NOTICE OF ADDENDUM

ADDENDUM NO. 2

CITY OF MADISON
NAKOOSA TRAIL FLEET/FIRE/RADIO SHOP FACILITY

A-108

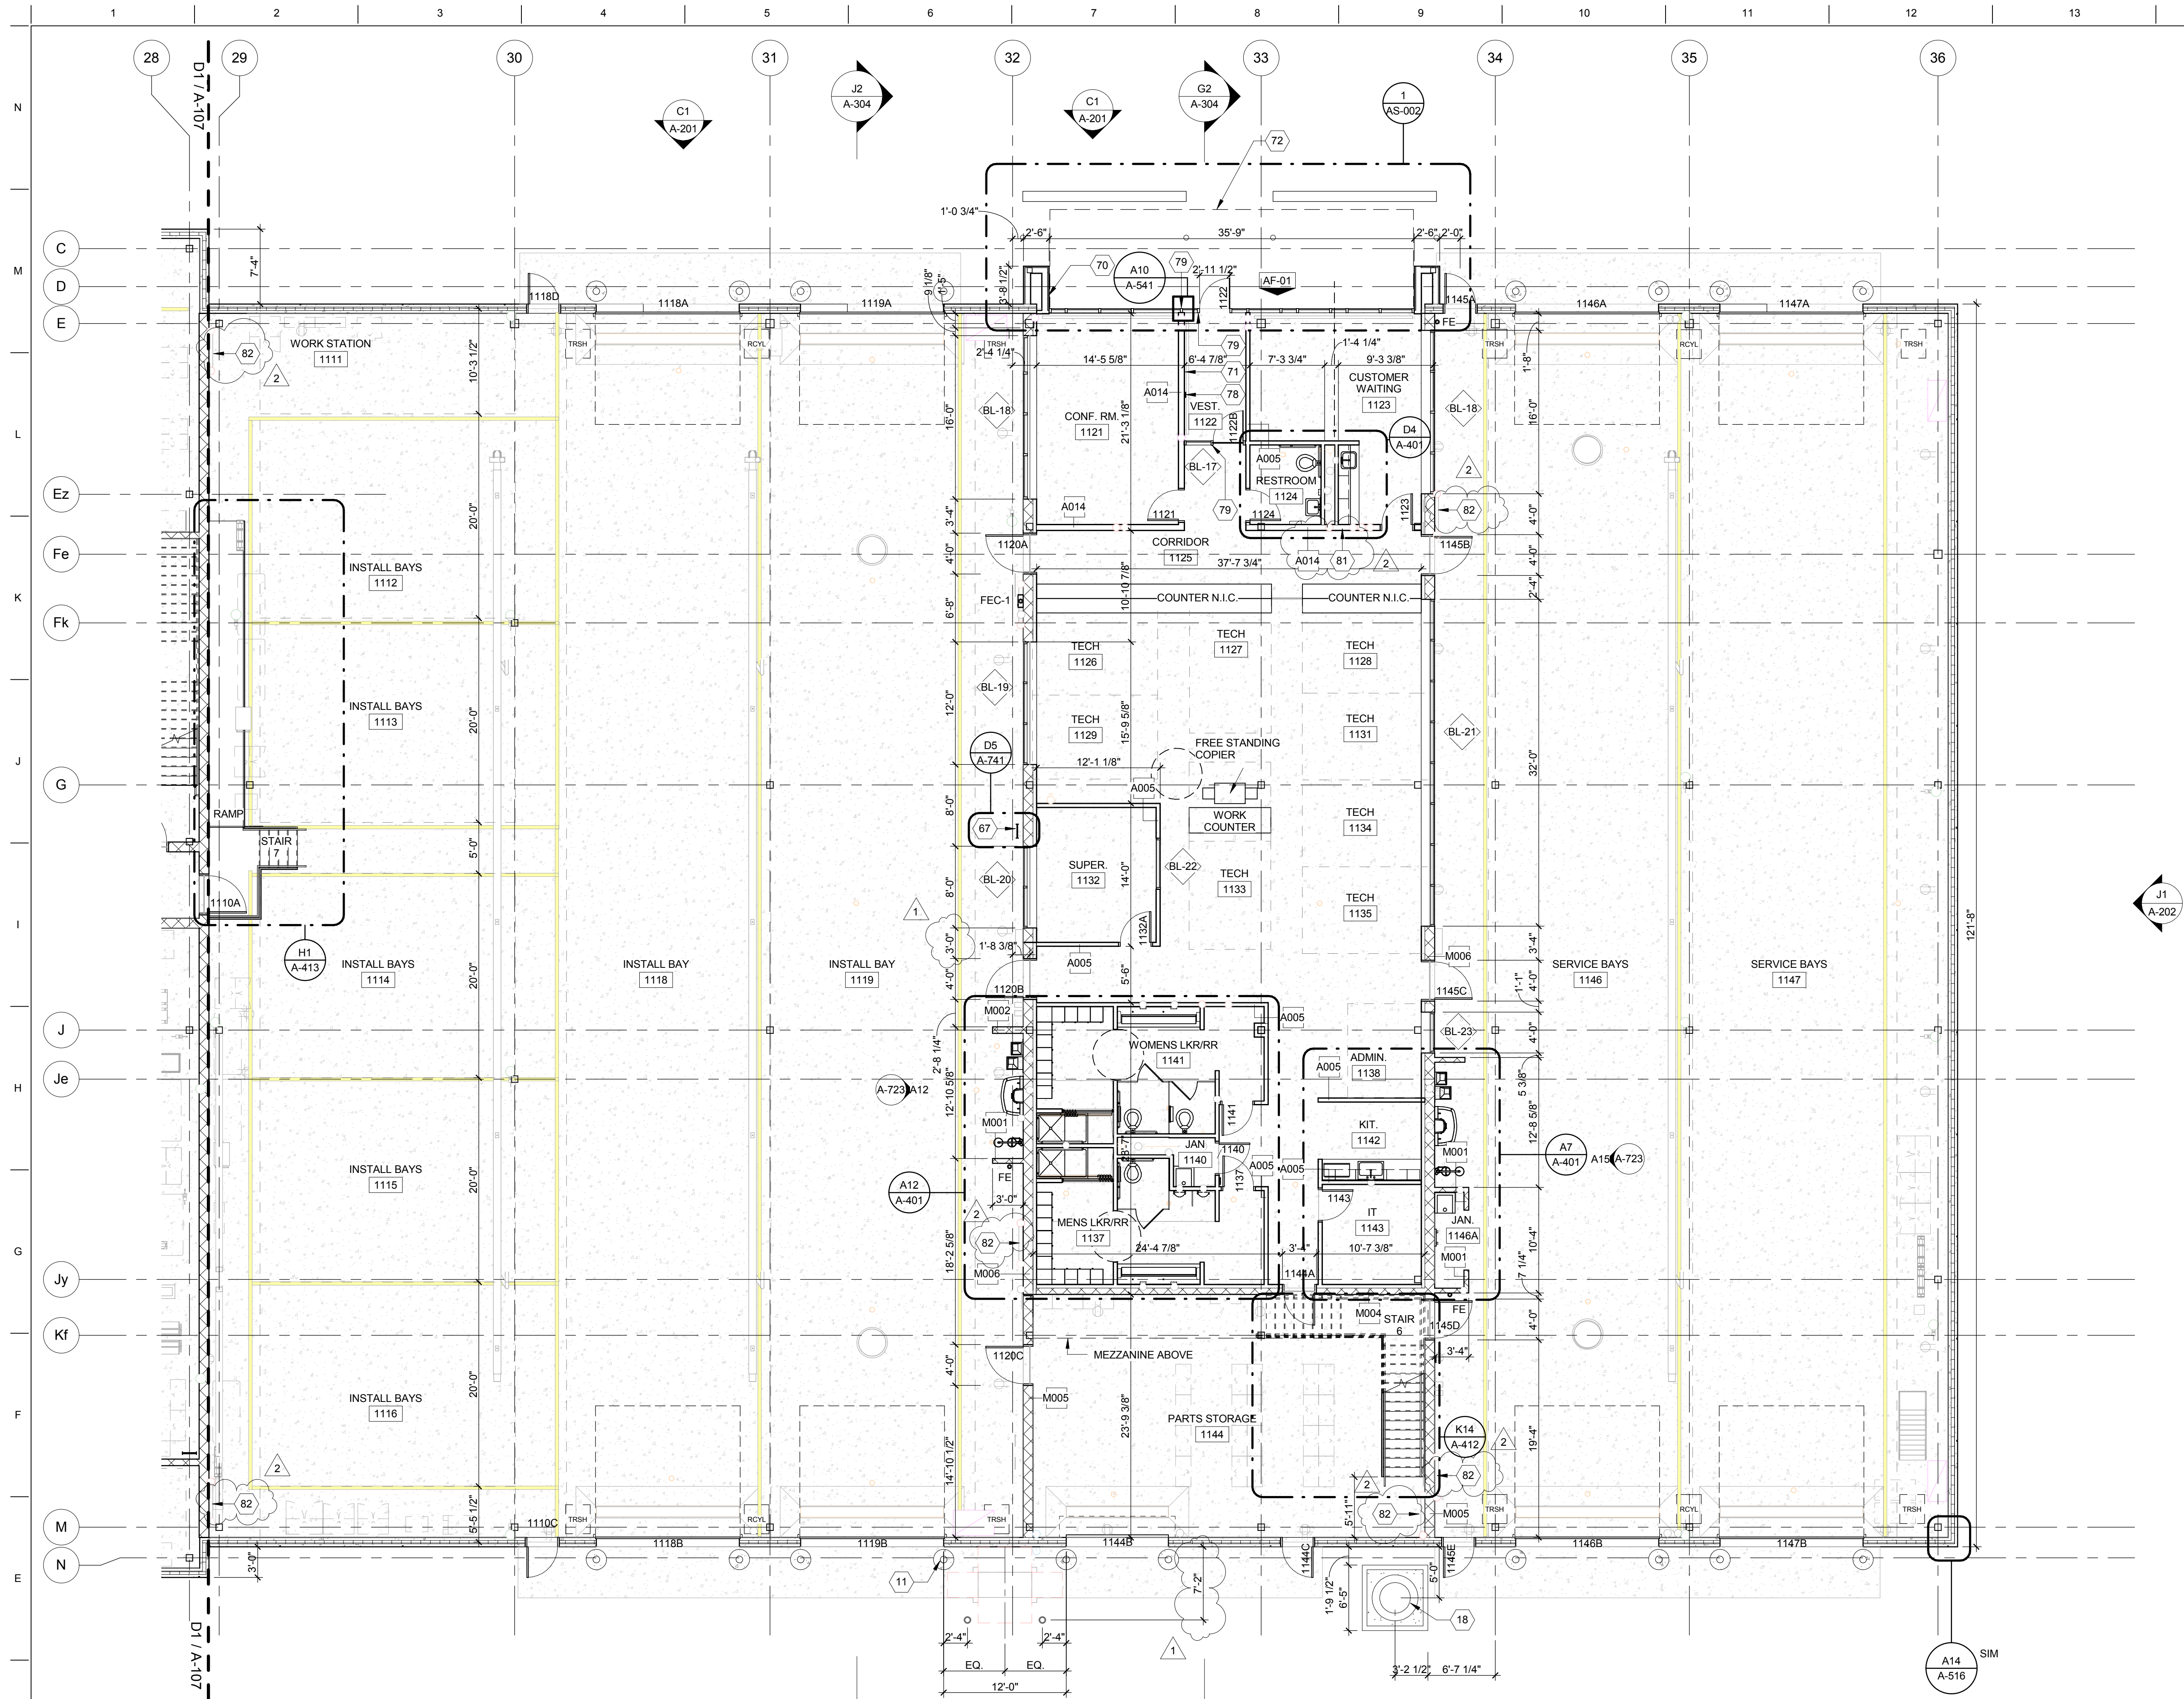
- P. **MODIFIED** A-108 LEVEL FLOOR PLAN E to:
 - a. Add key note for radiant flooring manifold mounting box location
 - b. Reviser fire extinguisher from wall mount to recess to comply with ADA requirements.

- c. Moved ladder location to accommodate relocation of mechanical equipment on mezzanine.
 - d. Revise bollard location to accommodate revise mechanical equipment layout.

- e. Add dimension for bollard location from building.
- Q. **MODIFIED** A-114 MEZZANINE FLOOR PLAN AREA B to revised ladder location and railing accommodate revised location of mechanical equipment on mezzanine.

A-200

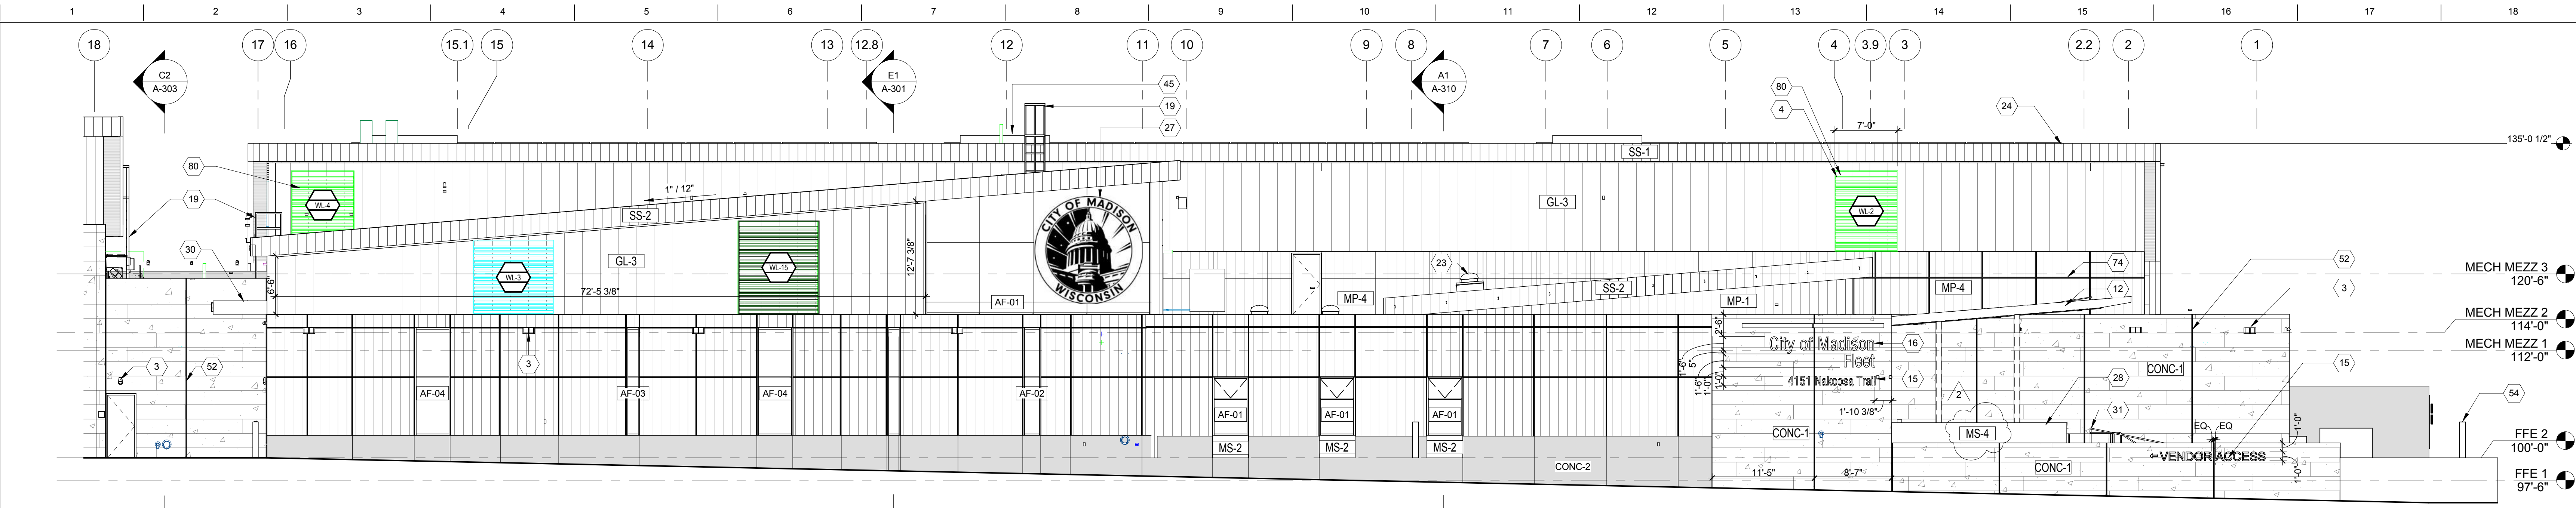
- T. **MODIFIED** A-200 EXTERIOR FINISH SCHEDULE remove MP-6 from schedule.
- U. **MODIFIED** A-201 BUILDING ELEVATIONS Drawing K1 to add material key note for the perforated metal screen near entry.

A-313

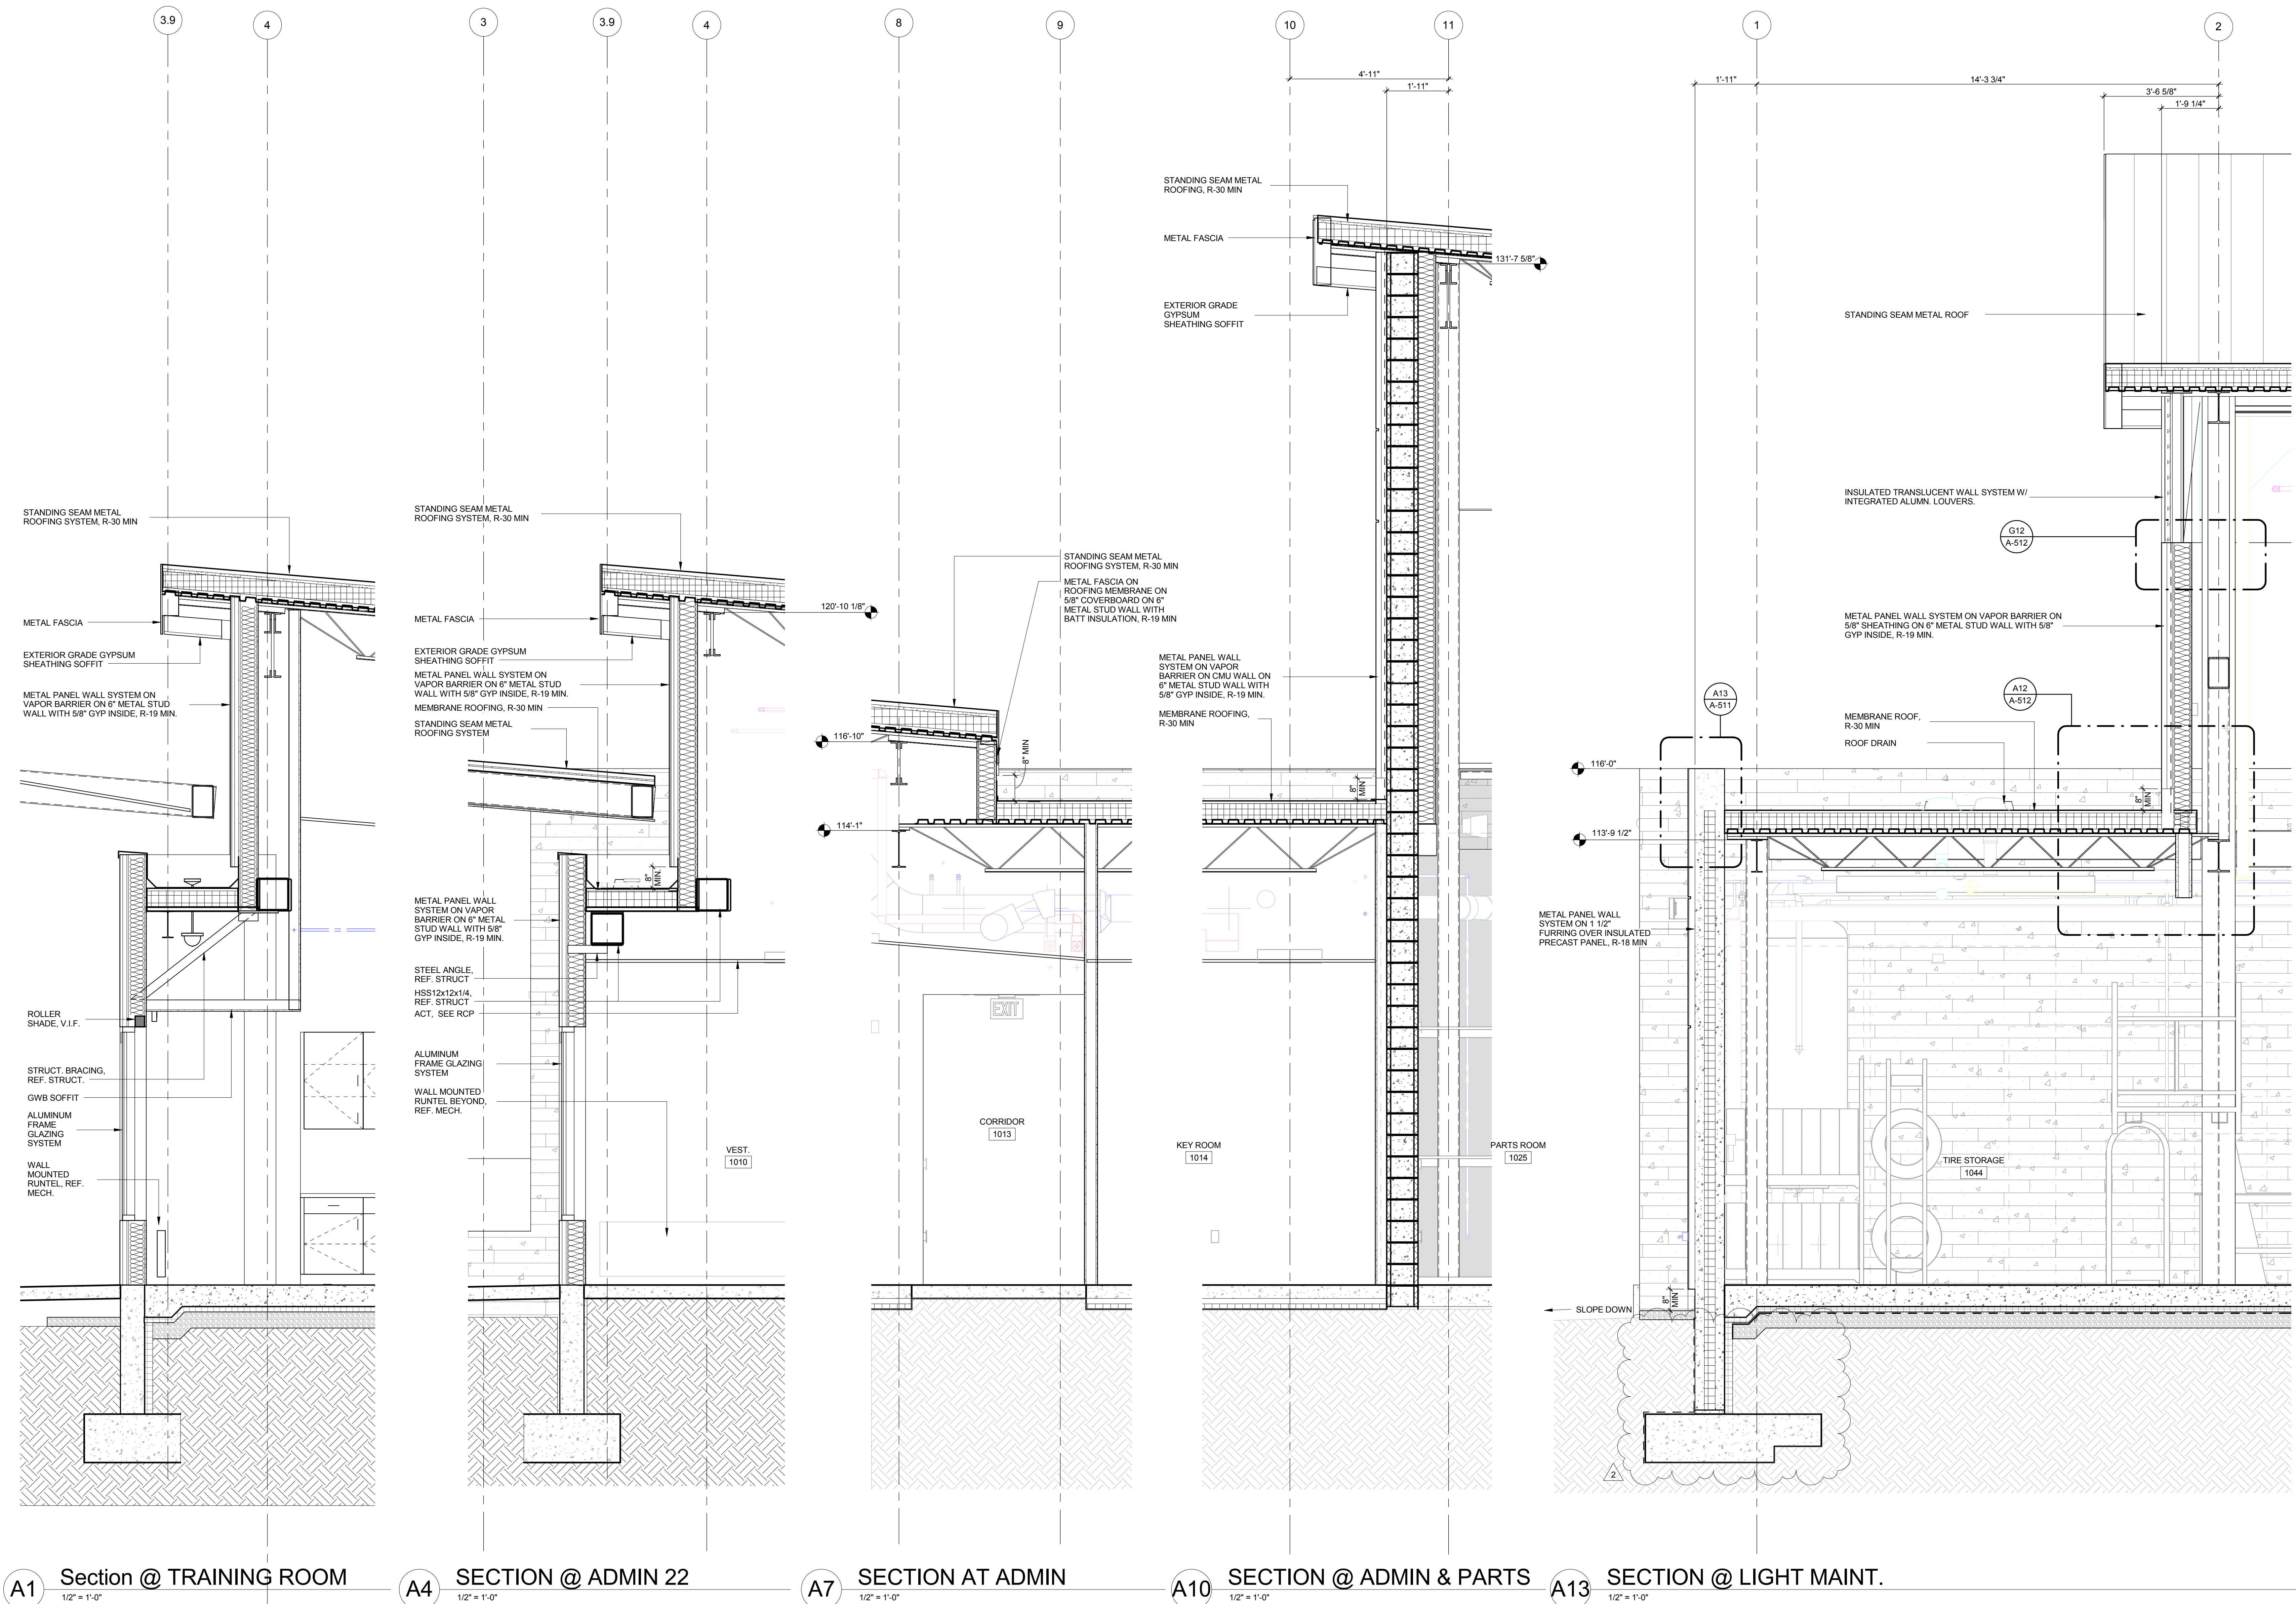
- Z. **MODIFIED** A-313 E/W WALL SECTIONS to update bottom of wall section to extend insulation past SOG to top of footing and to coordinate with structural detail.
